AGENDA OF THE LANDMARKS COMMISSION

WEDNESDAY, MAY 22, 2024, 4:30 PM
City Hall, Room 604 - The Harry Maier Room.
Virtual attendance is also available via Zoom.

Report to the
Landmarks Commission
of the City of Green Bay

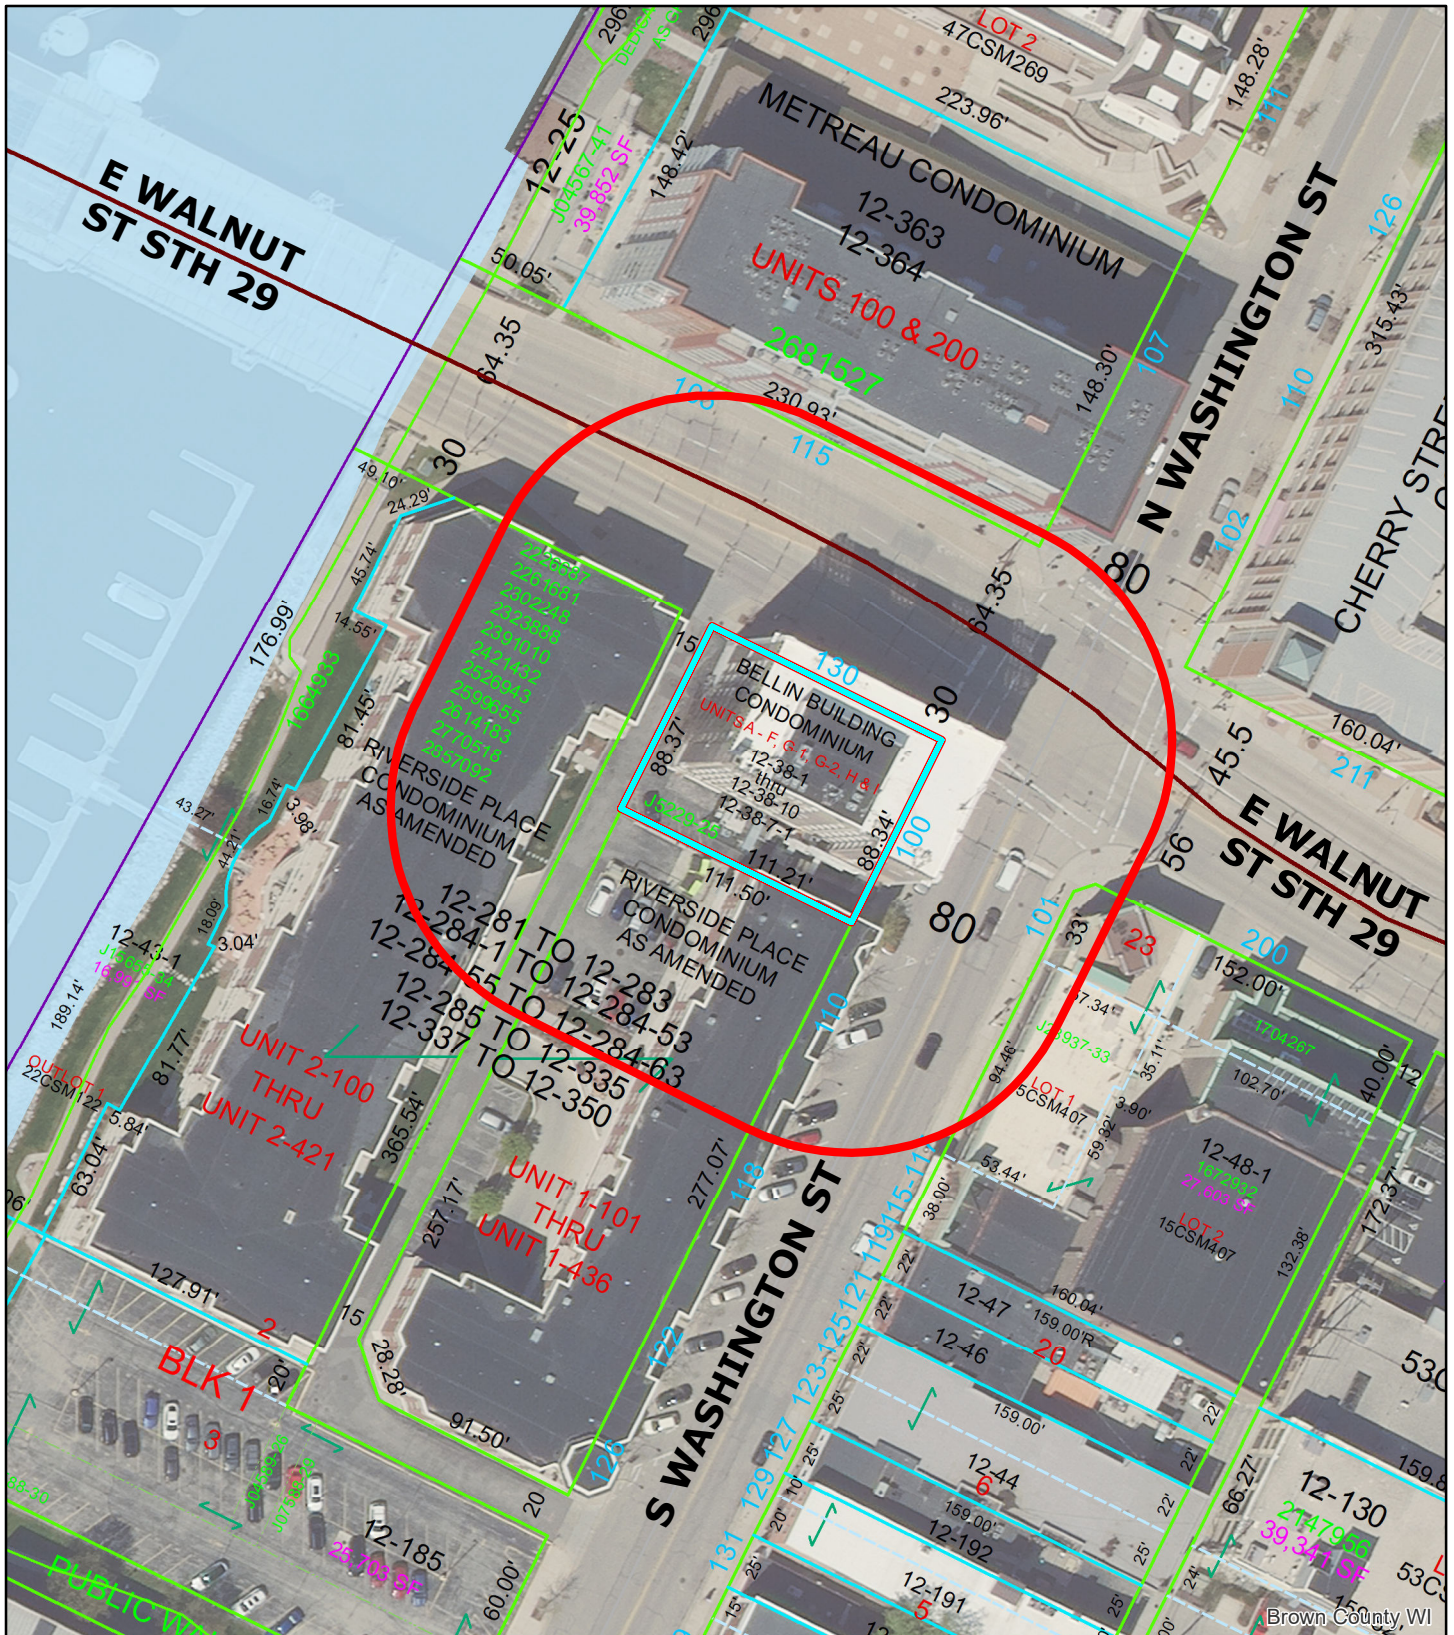
This COA proposes to paint a mural directly on the painted brick exterior of the rear (west) side of the building, facing an alleyway, visible from E Walnut Street. The mural is to be confined solely to areas of previously painted brick.

LC staff notes that the existing painted brick appears to be in reasonably good condition, with some spalling at ground level. LC staff also notes that there is an existing fire hose connection and some cabling that is present in way of the proposed mural.

LC staff recommends approval of this proposed mural if the paints to be used are highly vapor-permeable and all paint is to be confined solely to areas of previously painted brick. As an alternative, attaching painted dibond or some other material in a manner similar to a sign may be appealing.

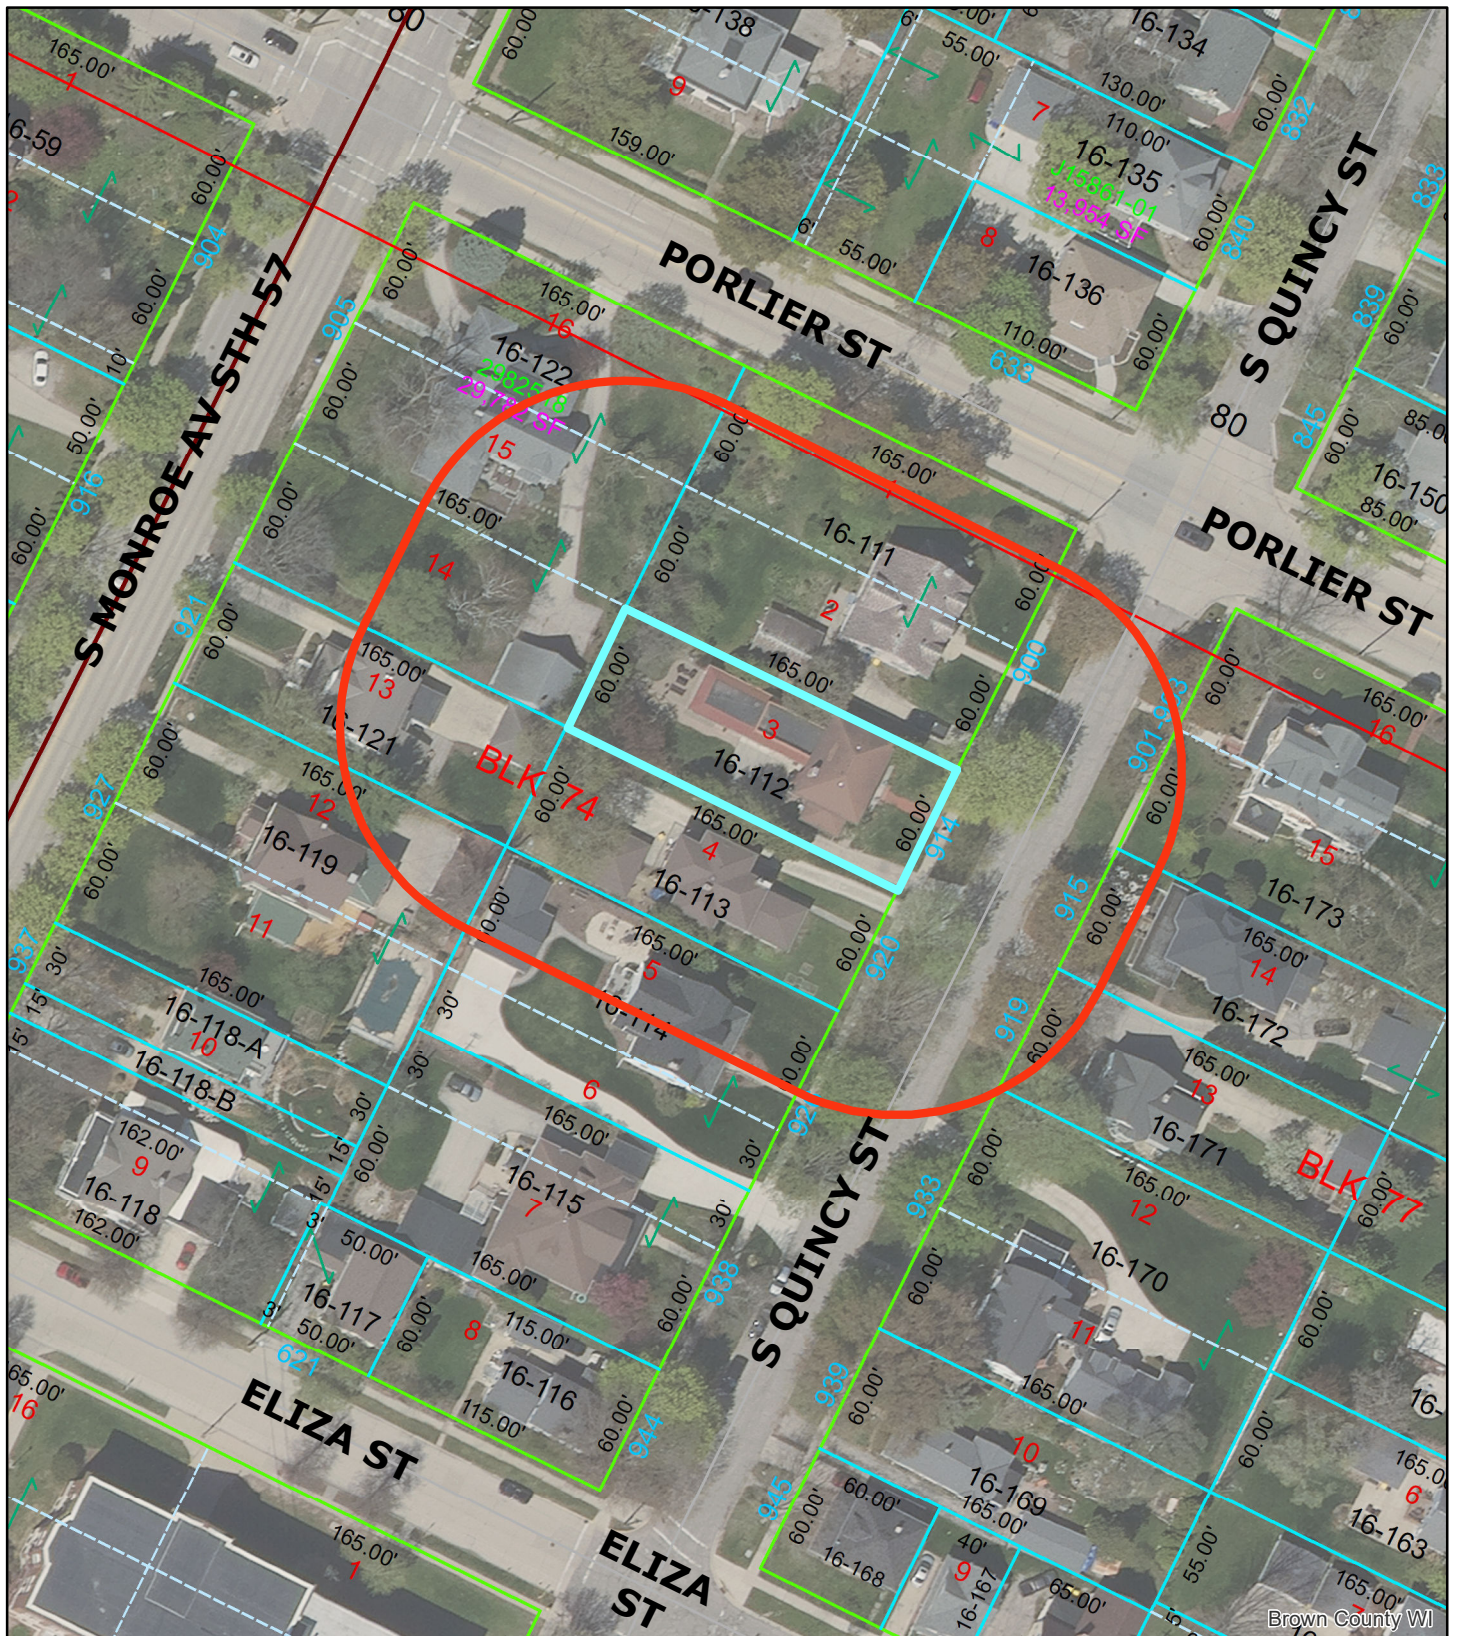
LC staff notes that the proposed solar panel installation of 14 panels on the street-facing east side of 914 S Quincy would negatively impact the historic character of the property and this portion of the district as they would be obtrusively visible from the public right-of-way.

LC staff recommends denial of the proposed solar panel installation on the east (street-facing) side of the roof of 914 S Quincy.

LC staff recommends approval of the proposed wooden storm window replacements.

Exterior Work for 735 South Jackson Street

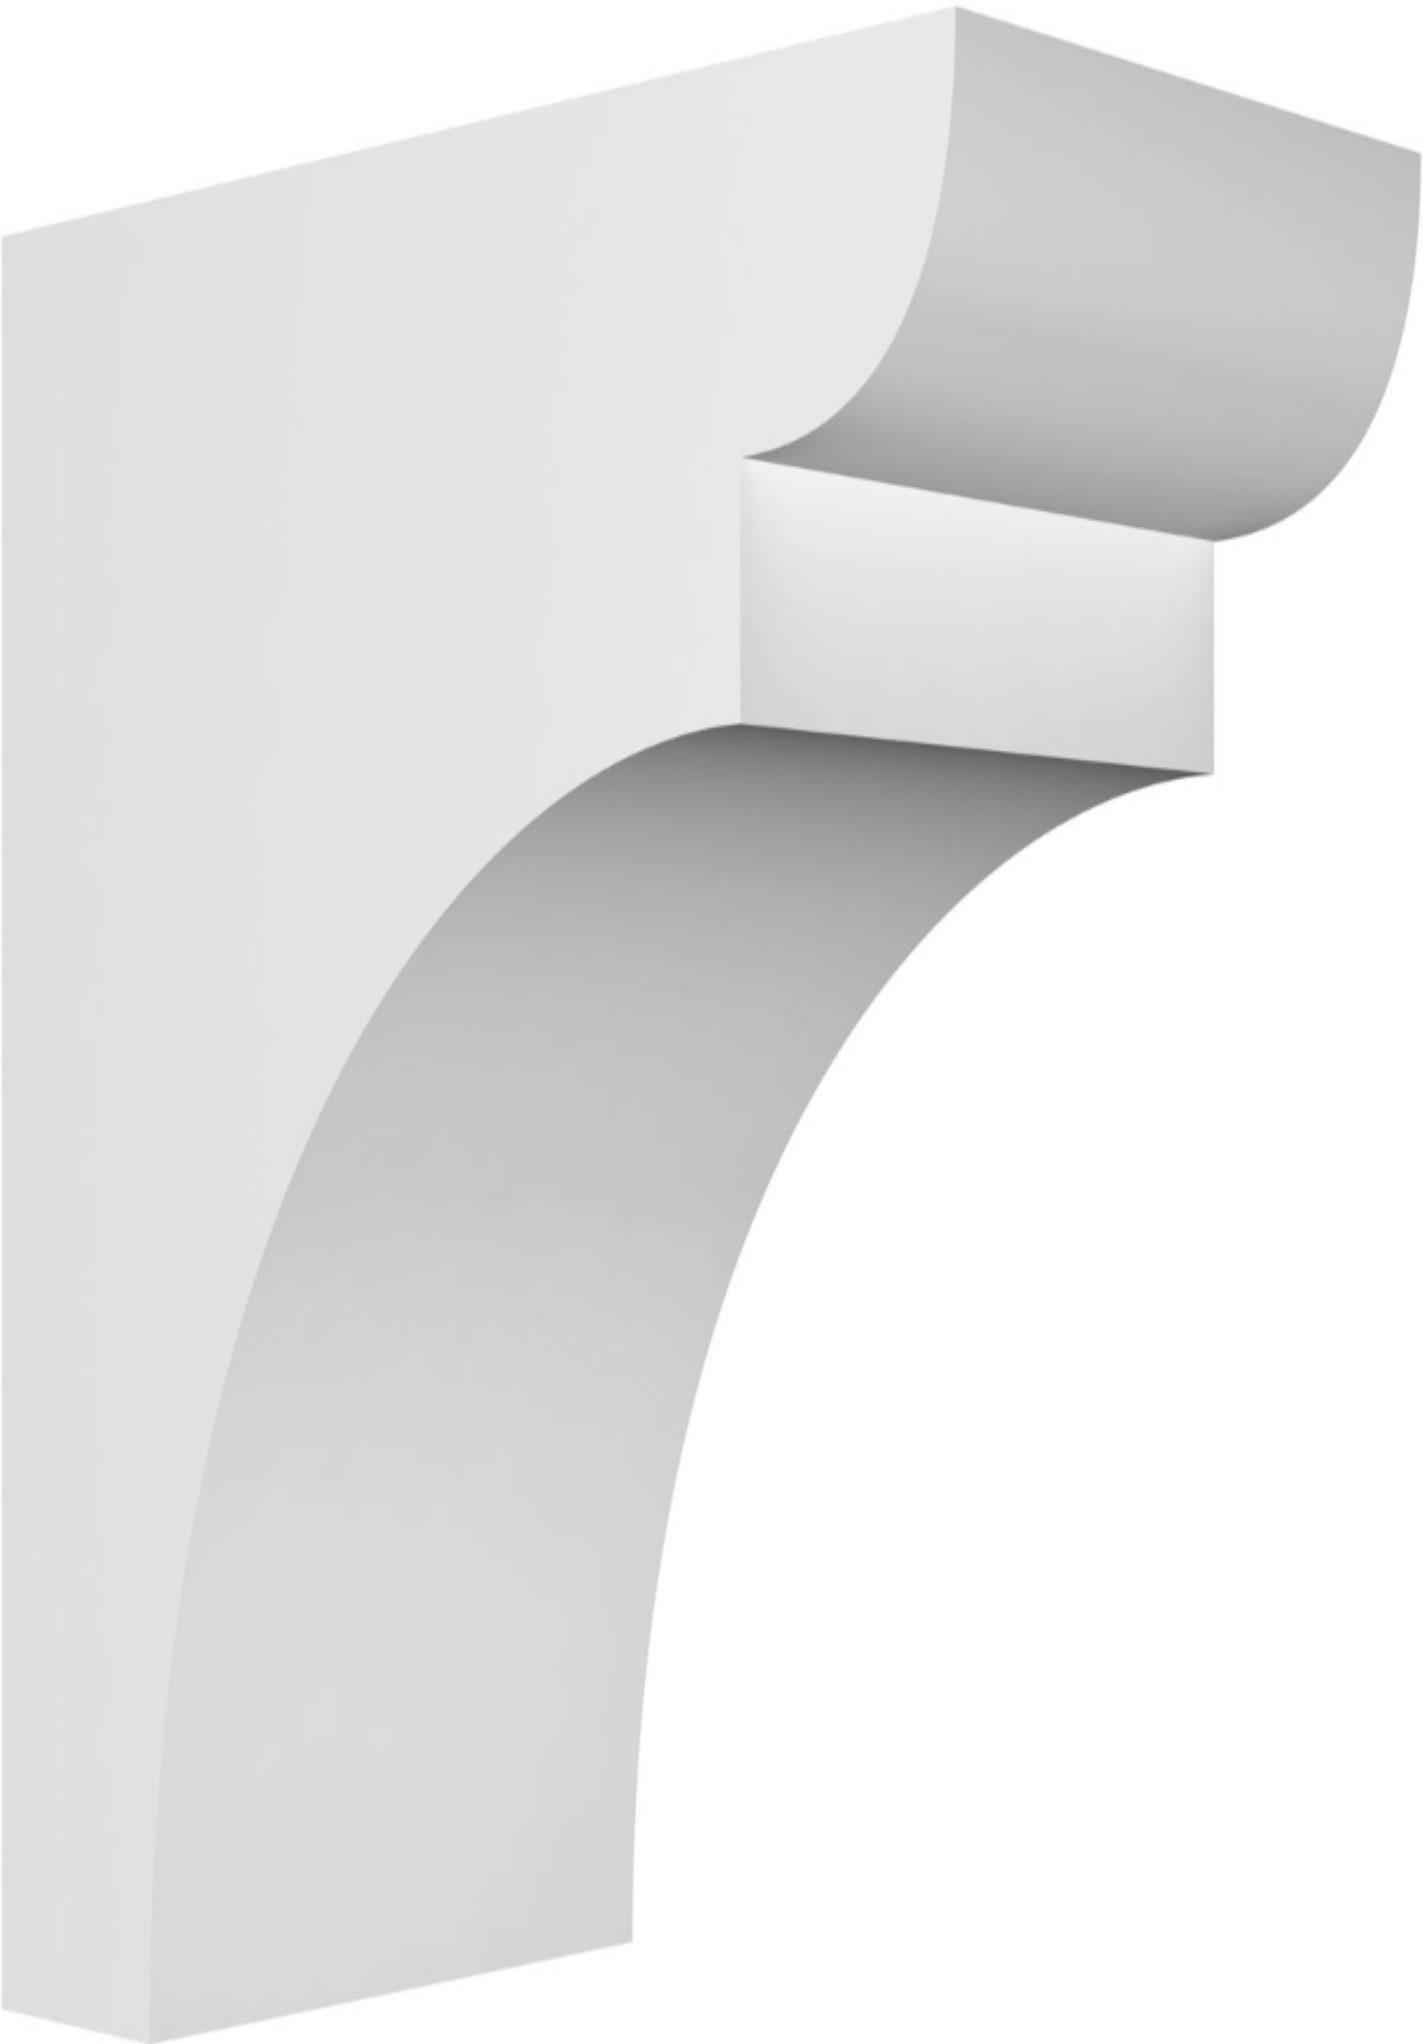
This house currently has vinyl siding (with an appearance that simulates clapboard siding) on the second story and a stucco exterior on the first story. The rendering provided with this application shows a different type of siding appearance for the second story – a random-width shingle appearance is proposed. Additionally, the rendering shows new clapboard profile siding covering the first story.

The proposal calls for replacing two doors above the one-story 'sunroom' with windows. These doors are on a side elevation, generally not visible or noticeable from the public right-of-way. It is unclear if doorways were historically present here, but their location on a secondary elevation with limited public view suggests that the proposed changes here would have a minimal impact on the historic integrity of the house and the larger district. No details for the proposed windows have been provided other than a conceptual rendering of the finished appearance.

The proposal calls for the replacement of a pair of small windows on the rear elevation with a pair of slightly larger windows of similar style. It is unclear if the existing windows are historic (detail views of the existing windows have not been provided). Given the location of this proposed change (rear elevation not visible from public vantage points), this change will have a negligible impact on the historic integrity of the property and that of the larger district.

The proposal calls for the addition of architectural corbels or modillions under the roof eaves where there are currently none. LC staff notes that the rendering provided identifies the locations of these proposed additions – a note of caution, the rendering also may imply that the existing corbels (possibly character-defining features of the property) flanking the front door are to be removed and replaced.

- #1 – Roof – approval, noting tax credit opportunity.
- #2 – Gutters – approval, noting half-round design would be an optional improvement.
- #3 – Siding – discussion. SOI # 6 indicates that shingle-style siding is an inappropriate replacement for clapboard-style siding in the second story, and SOI # 2 & #4 suggests that the stucco exterior at the first story may warrant retention & preservation.
- #4 – doors – approval, provided new windows are appropriate (no details / cut-sheet provided)
- #5 – rear windows – approval, approval, provided new windows are appropriate (no details / cut-sheet provided)
- #6 – corbels/modillions – denial, SOI # 3, conjectural feature. Note unclear if changes are proposed concerning the existing corbels (possibly character-defining features) at front door sides.
